TECHNICAL MEMORANDUM

DATE: January 18, 2011

RE: **ADDENDUM NO. 1 RI/FS WORK PLAN
FORMER COLLINS BUILDING LOCATION INVESTIGATION
NORTH MARINA AMERON/HULBERT SITE
EVERETT WASHINGTON**

Figure
1

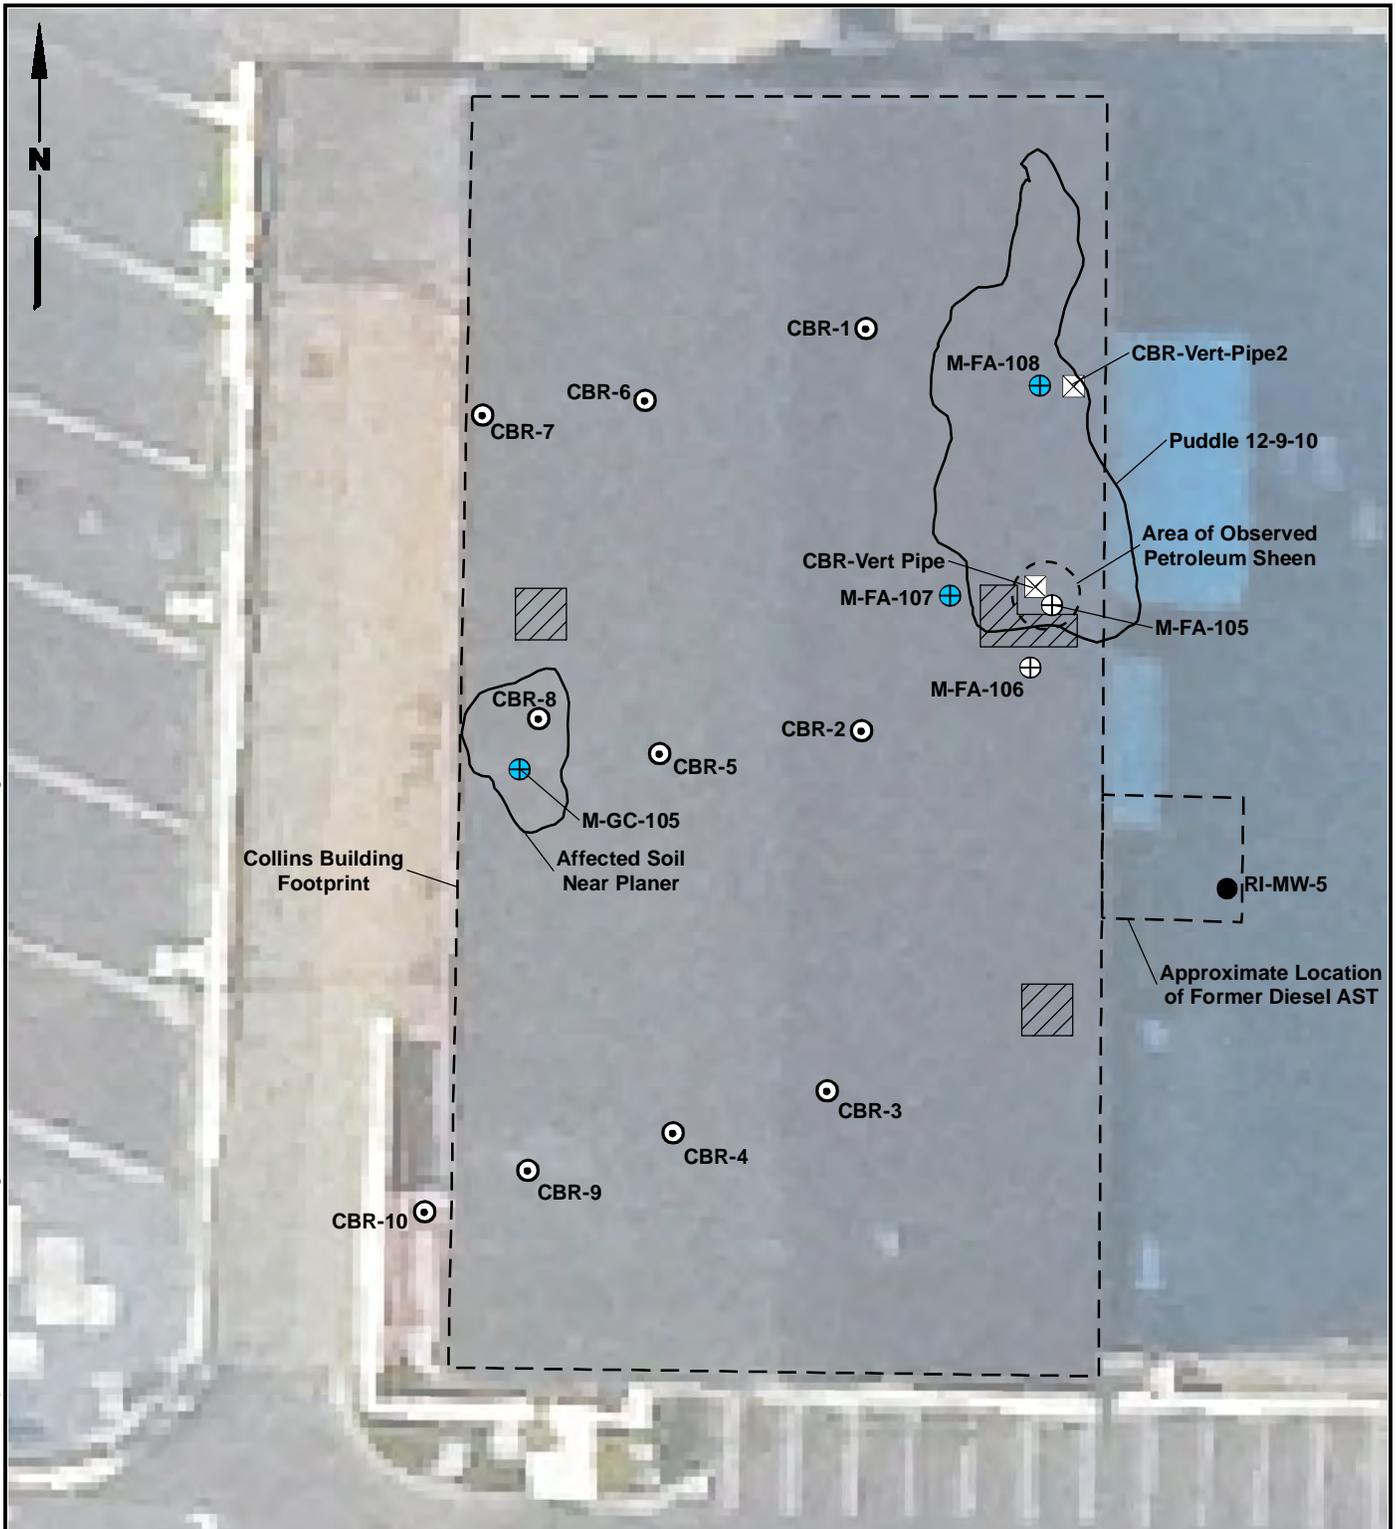
Surface soil at 10 locations was field-screened for VOCs using a PID. The screening locations are shown on Figure 1. Elevated PID readings were not recorded at any of the screening locations. Standing water was observed over much of the eastern one third of the former building area; therefore, surface soil screening was not completed in this area.

An ecology block wall was observed to the south of the former building area, and along the southern portion of the western side of the former building area. Rust-colored gravel was observed on the ground surface along the block wall on the west side of the former building area. Woodchips were observed on the ground surface in several areas. Three concrete pads were observed within the former building footprint and are shown on Figure 1. The pads are believed to be foundations associated with former equipment.

Two vertical pipes were observed in the northeastern portion of the former building area and are shown on Figure 1. The first is located directly north of a concrete pad and is believed to be associated with a former elevator. A petroleum sheen was observed on standing water in this area. A second pipe was observed farther north. The purpose of this pipe is not known, but it was observed to largely be filled with wood debris at the time of the reconnaissance.

- Relocate previously planned direct-push location M-GC-105 approximately 30 ft east to the location of the oil-stained material observed in the West Area and modify the proposed sampling strategy and analytical parameters as indicated below.
- Collect samples of oil-stained material (by hand), the hydraulic fill directly below the oil-stained material, and from the capillary fringe or at 4 ft BGS if soil is saturated to the ground surface.
- Collect a groundwater sample.
- Analyze soil and groundwater samples for unknown oil parameters identified in Model Toxics Control Act (MTCA) Table 830-1 including additional parameters [VOCs;

- Advance three direct-push soil borings (M-FA-105, M-FA-106 and M-FA-107) to a depth of 20 ft BGS to the north, south, and west of the concrete pad.
- If evidence of impact is found, collect soil samples from possibly impacted material and below impacted material based on previously described field screening procedures. If evidence of impact is not observed during drilling via field screening, soil samples will be collected from surface soil and from the capillary fringe; the second sample will be collected at about 4 ft BGS if soil is saturated to the ground surface.
- Collect a groundwater sample from the boring to the west of and downgradient of the concrete pad (M-FA-107).
- Analyze soil and groundwater samples for unknown oil parameters identified in MTCA Table 830-1 including additional parameters [VOCs, cPAHs, SVOCs, PCBs, metals, TPH-

- Advance one direct-push soil boring (M-FA-108) to a depth of 20 ft BGS to the west of the standpipe.
- Collect soil samples from possibly impacted material observed during drilling based on previously described field screening procedures, and from below impacted material. If evidence of impact is not observed during field screening, a soil sample will be collected from surface soil and from the capillary fringe, or at about 4 ft BGS if soil is saturated to the ground surface.
